# Memorandum

RE: PZ -06-2023 Chesterfield Village Mall (TSG Downtown Chesterfield Redevelopment, LLC)

Green Sheet Amendments

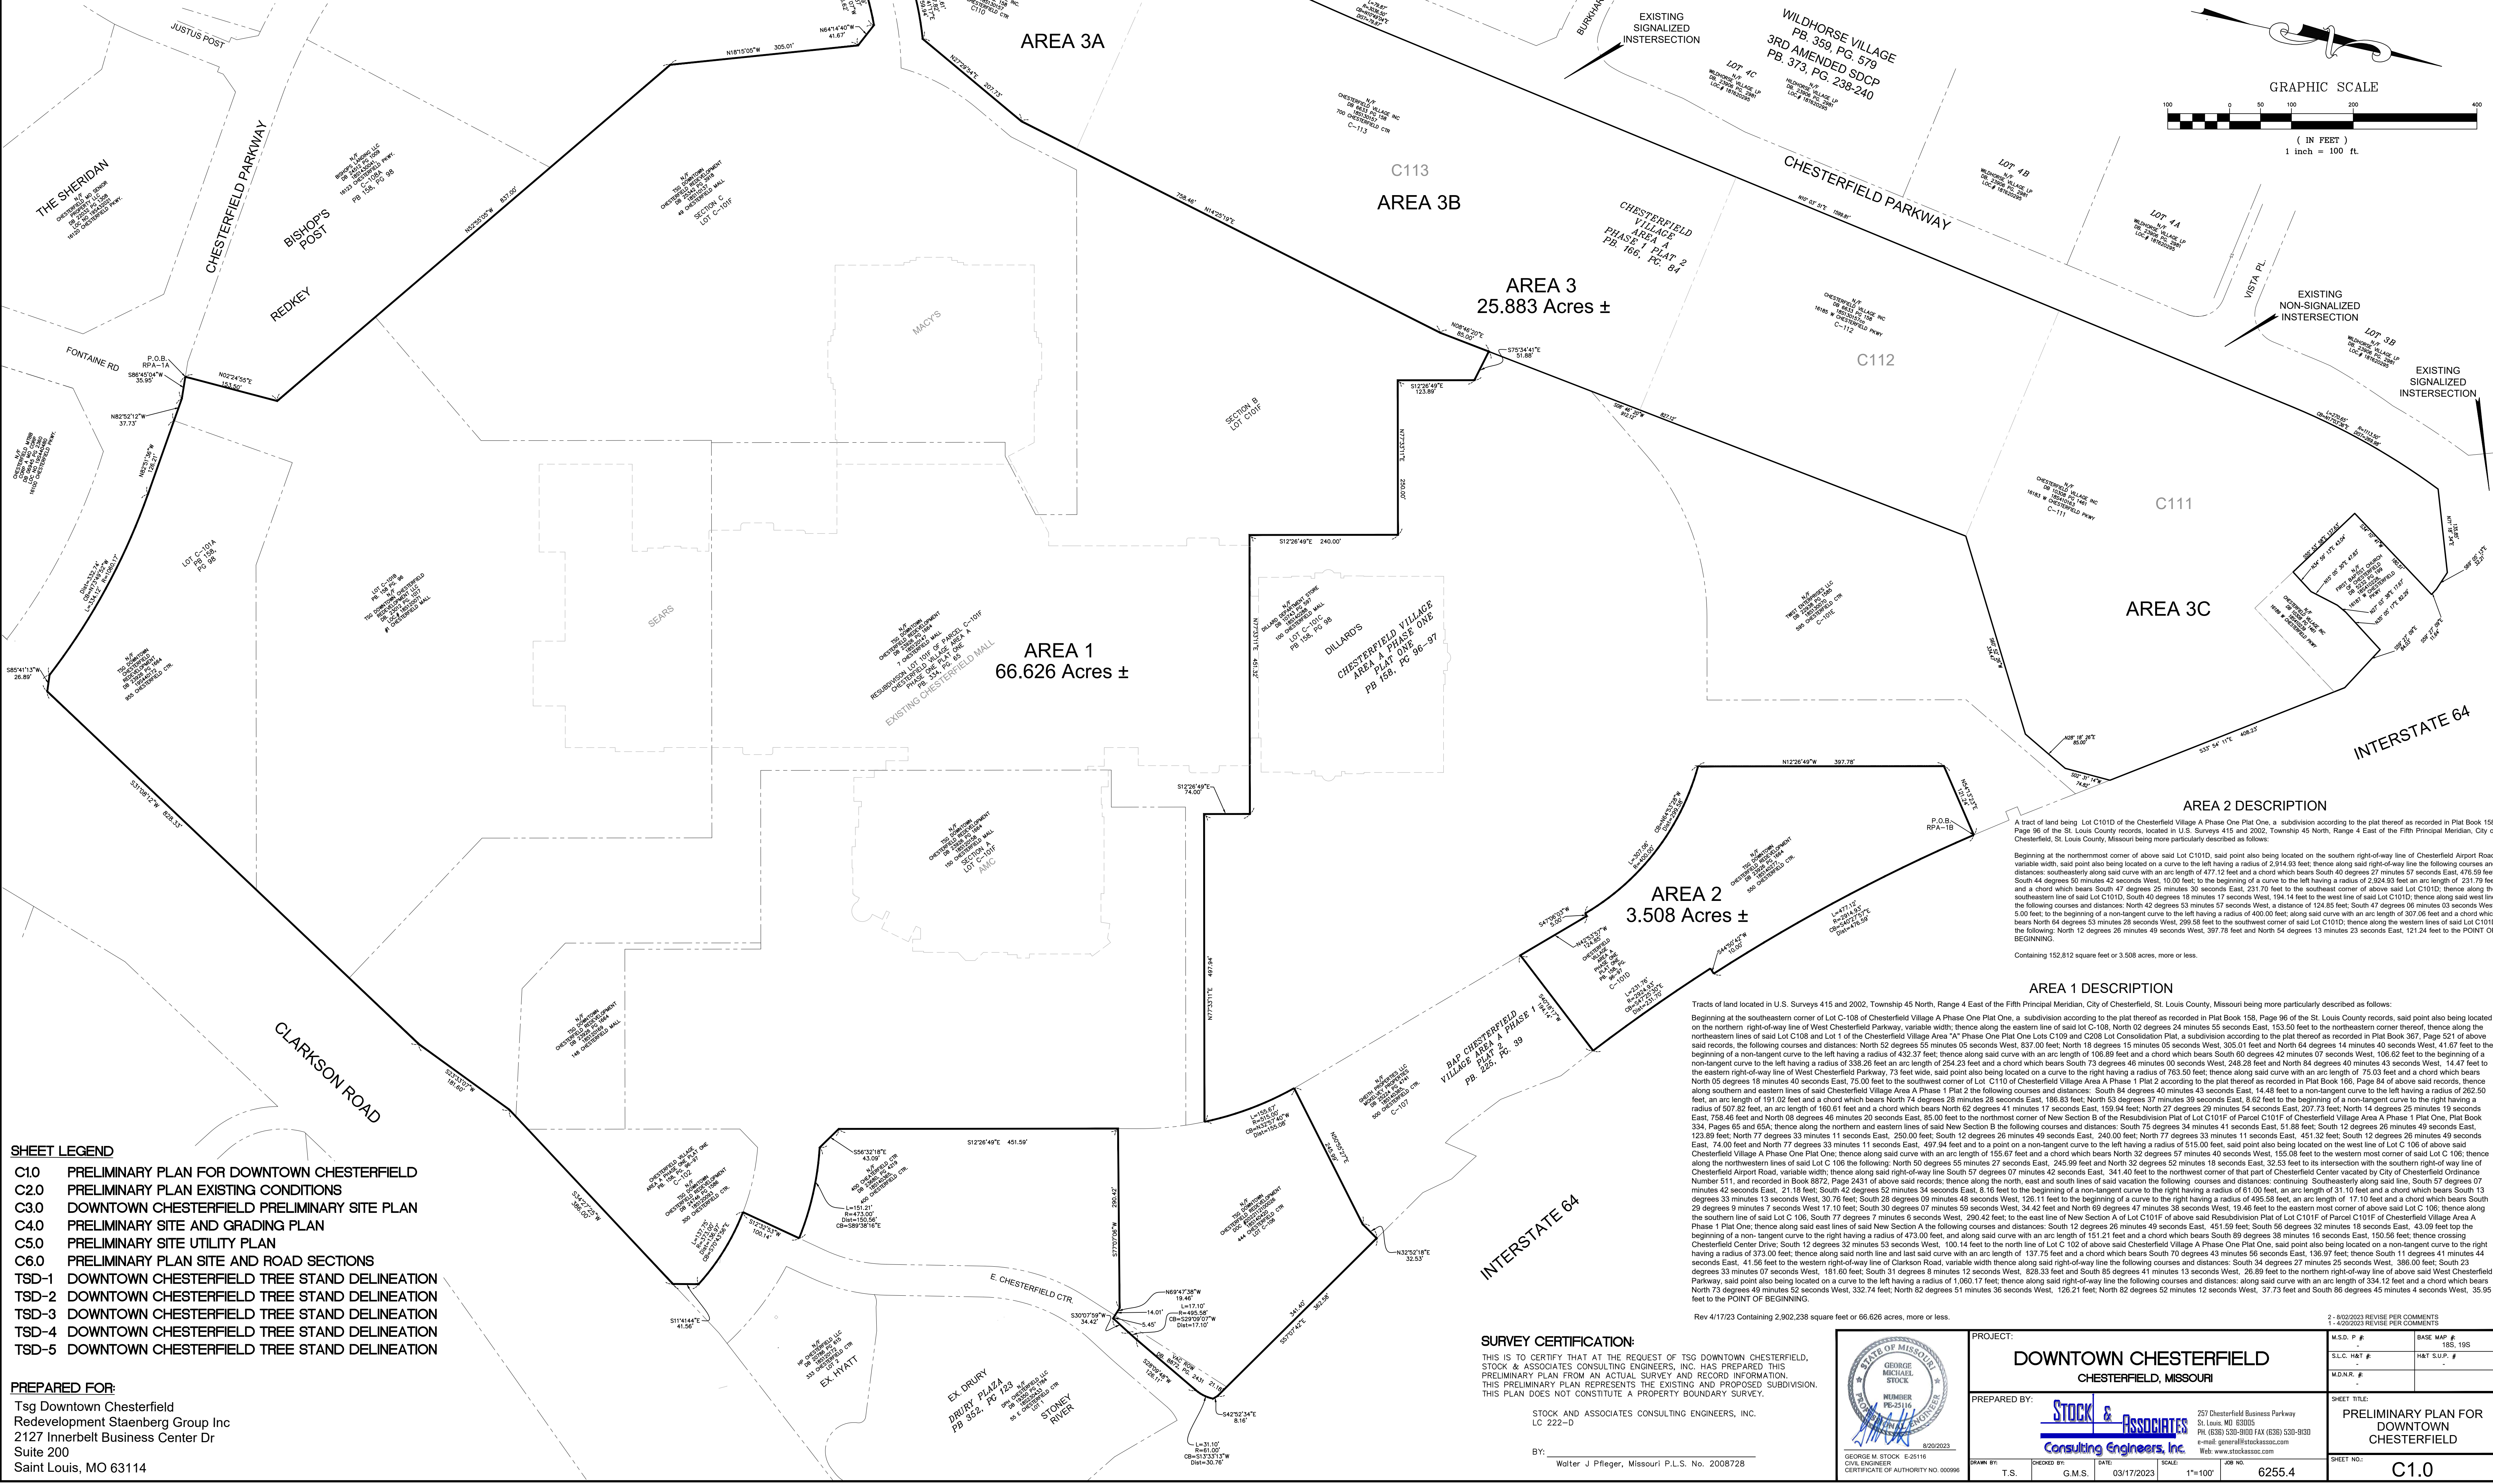
On July 20, 2023, The Planning and Public Works Committee met and discussed at length concerns raised during and after the Planning Commission process. To aid in the discussion of each point relating to the proposed Attachment A and possible green sheet amendments, a matrix is attached. The matrix lists each issue/concern and staff's response, in consultation with the Applicant. The matrix does not address the question of residential density since the issue is more complex and has not yet been resolved. Also attached is the revised Preliminary Development Plan that removes the blue dotted lines which had indicated conceptual building lines. It also adds sidewalks/bike paths from the outer ring road to Chesterfield Parkway at Fontaine, Lydia Hill and Vista Place. Sidewalks are to be added from the Grand Staircase to Chesterfield Parkway. The side street shown on the original Preliminary Development Plan on the Sachs Parcel east of Chesterfield Parkway will no longer connect to Park Circle at the Grand Staircase. The only access to this portion of the development will be from Burkhardt. Finally, a notation on the Preliminary Development Plan will be added to Park Area R2 that shall state "Park Area with Amenities and Public Parking Garage Underneath".

New Note	New Note	Remove blue dotted conceptual/proposed building outlines from PDP.	Revised Preliminary Development Plan includes this modification.
New Note	New Note	Add sidewalks from all locations on Outer Loop Road to Chesterfield Parkway on PDP. (Lydia Hill, Vista Place and Fontaine)	Revised Preliminary Development Plan includes this modification.
New Note	New Note	Add sidewalks from Grand Staircase to Chesterfield Parkway on PDP.	Revised Preliminary Development Plan includes this modification.
New Note	New Note	Add bike path from Outer Loop Road to Chesterfield Parkway at Lydia Hill, Vista Place and Fontaine on PDP.	Revised Preliminary Development Plan includes this modification.
New Note	New Note	Access to the housing development shall only be via the entrance at Burkhardt. No vehicular access will be provided from Park Circle at the Grand Staircase.	Preliminary Development Plan includes this modification.

I.B.4		Open Space-add to Preliminary Development Plan language on the plan that states Park Area R2: “Park Area with Amenities and Public Garage Parking Underneath”	Revised Preliminary Development Plan includes this modification.
I.B.4		Open space: add public art to list of required items on the SDCP and/or SDSPs.	Proposed Language: Additional open space including pocket parks, plazas, natural areas, seating areas <b>and location of public art</b> shall be depicted on the SDCP and/or SDSPs.
I.C.3		Dock Loading	Proposed Language: Trash pickup, <b>building</b> receiving <b>and</b> loading, utility and service functions shall be located <b>at the rear of buildings along</b> the outer loop road and <b>off</b> service alleys <del>when feasible</del> .
I.D.		Parking and Loading Requirements should be detailed	In this instance, public parking garages and on-street will satisfy the parking requirements for the ground floor
